**LONDO FORBES CREEK**

Kirkland, Washington

Subject: Response to Peer Review Comments  
Londo Forbes Creek  
20<sup>th</sup> Avenue and 4<sup>th</sup> Place  
Kirkland, Washington

2

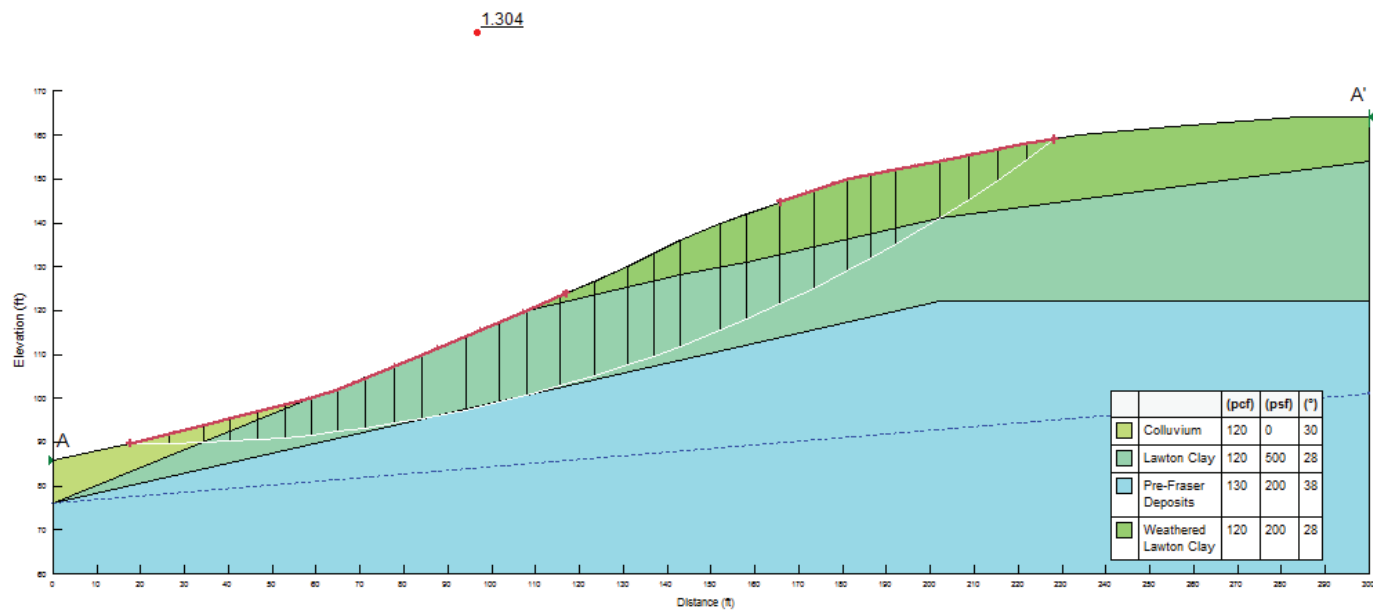
***KZC [Kirkland Zoning Code] 85.15 #1*** - *The code requires a plan that identifies areas with a slope of 15 percent or greater. The existing condition plan, Sheet EC-01, identifies areas with slopes greater than 40%. We recommend revising this to require the applicant to include a site plan identifying the areas meeting the KZC classifications of "High" and "Moderate" Landslide Hazard Areas. The areas should be hatched and clearly marked to assist in the determination of what areas will be impacted by the proposed development. Additionally, these areas should be shown on the proposed preliminary grading and building/retaining wall layout plan. This plan should be included as a figure in the geotechnical investigation report.*

As stated in our February 20, 2018 report: *“Given the predominance of fine-grained ‘Lawton Clay’ deposits encountered in our recent exploration borings, the portions of the subject site greater than 15 percent would be classified as ‘High Landslide Hazard Areas’, as defined in the KZC.”* We recommend that the portions of the subject site with a slope greater than 15 percent be marked as “High Landslide Hazard Area” per KZC. We will incorporate the updated project plan as the base plan for Figure 2 of our geotechnical report.

**SLOPE STABILITY - EXISTING  
CROSS-SECTION A - A' SEISMIC  
LONDO FORBES CREEK  
KIRKLAND, WASHINGTON**

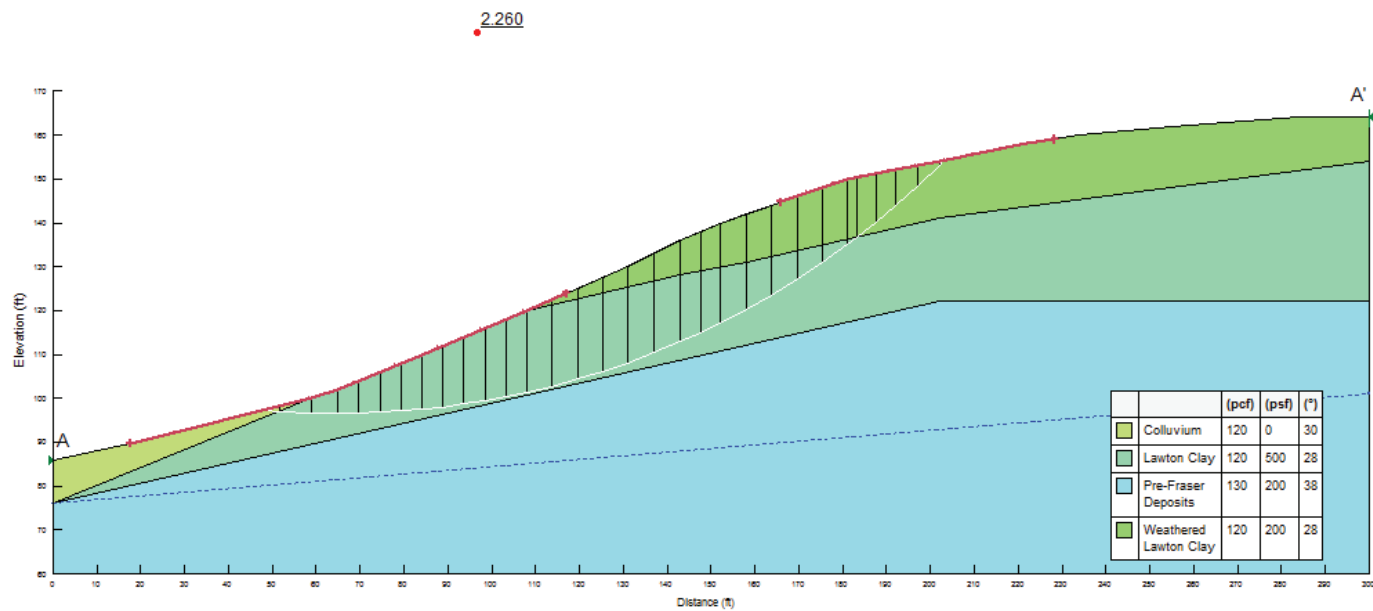
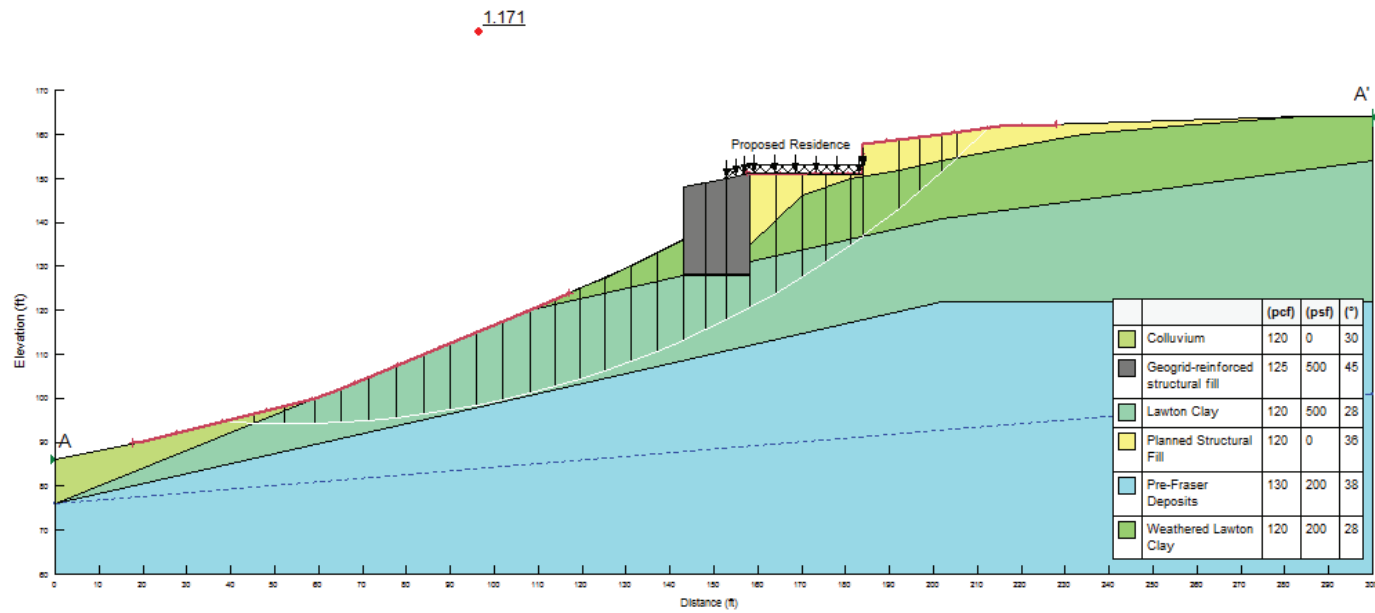
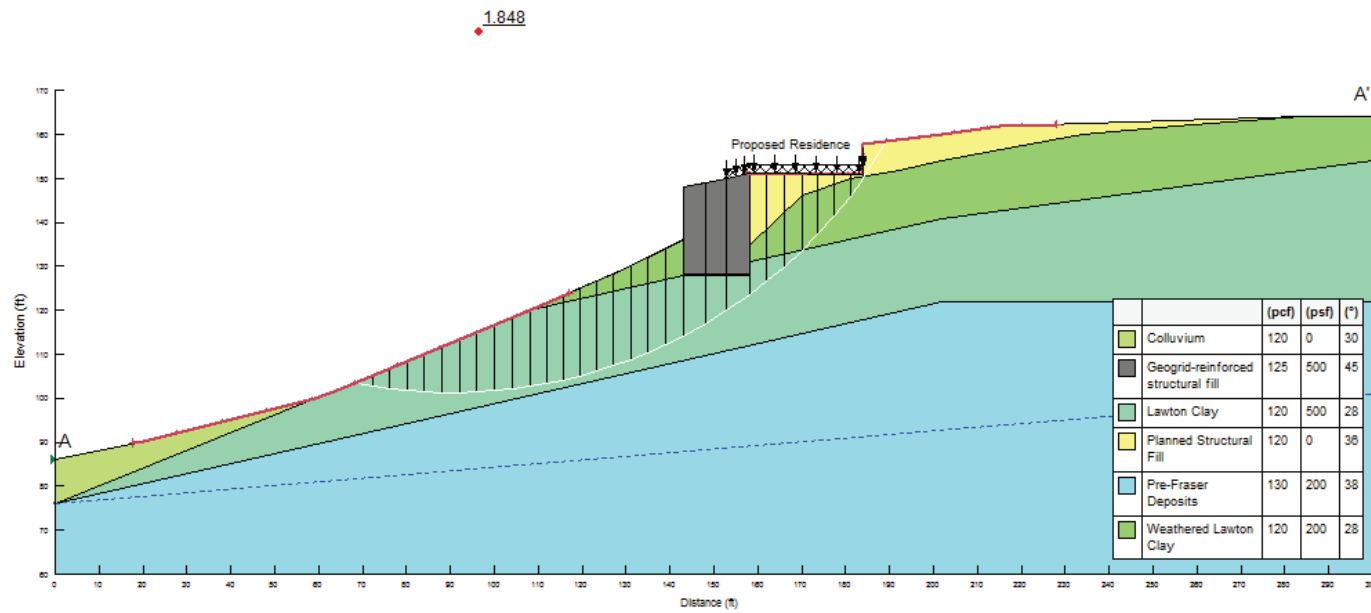
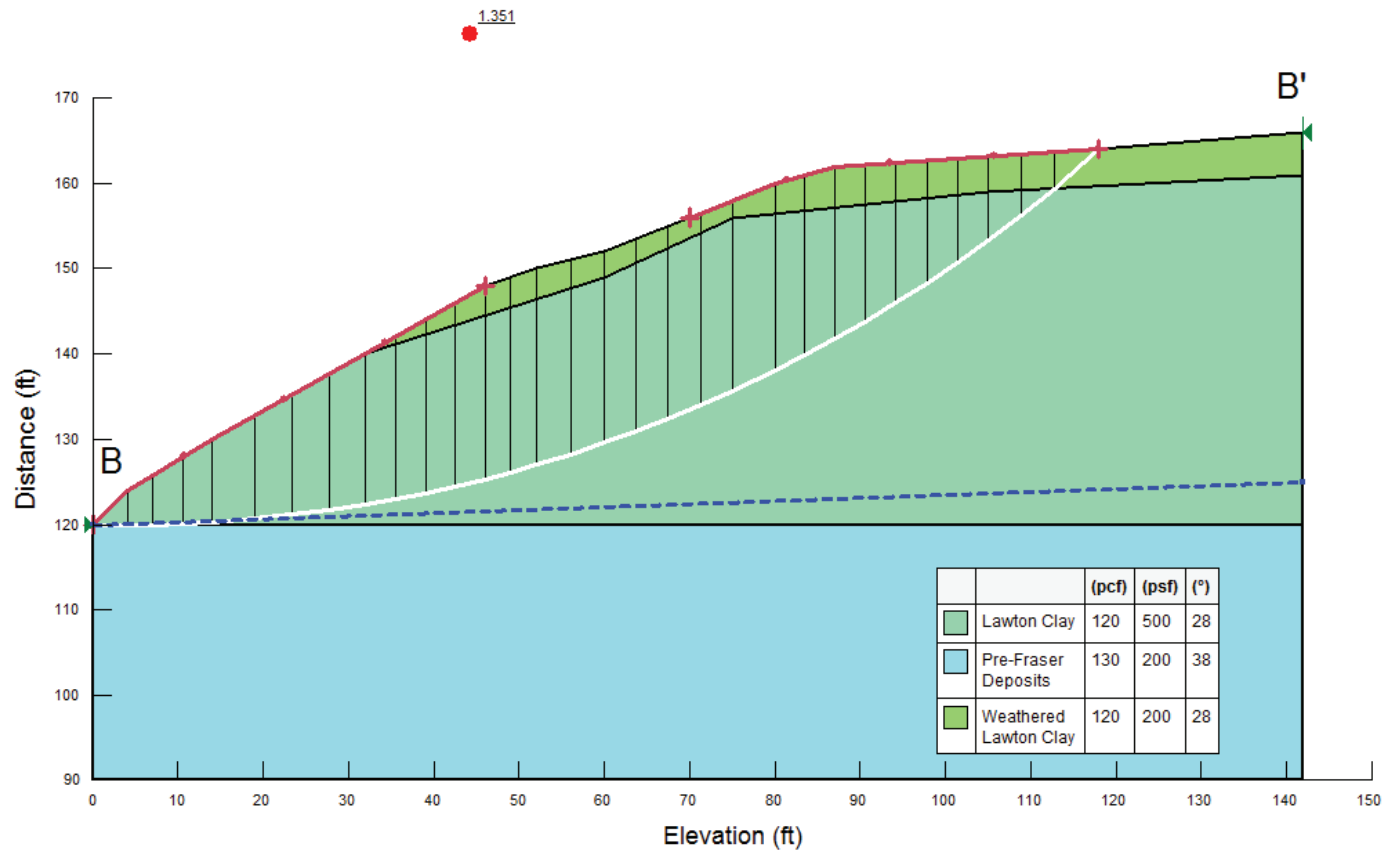
**KZC 85.15 #4, a** - *Slope stability analyses of the existing site conditions are also required to verify how the proposed grading will impact existing slope stability.*

Using the soil parameters presented in our February 20, 2018 report, we completed slope stability analyses of existing site conditions along the cross-sections presented in our February 20, 2018 report (Cross-Sections A-A' and B-B'). Soil strength parameters used for our analysis, along with interpretive geologic cross-sections and critical slip surfaces calculated under both static and seismic conditions, are shown on the attached figures. Our previous analyses for the planned conditions Cross-Sections A-A' and B-B' are included for reference. The resulting factors of safety for slope movement for existing conditions along the modeled cross-sections exceeded 1.50 under static conditions and 1.15 under seismic conditions.
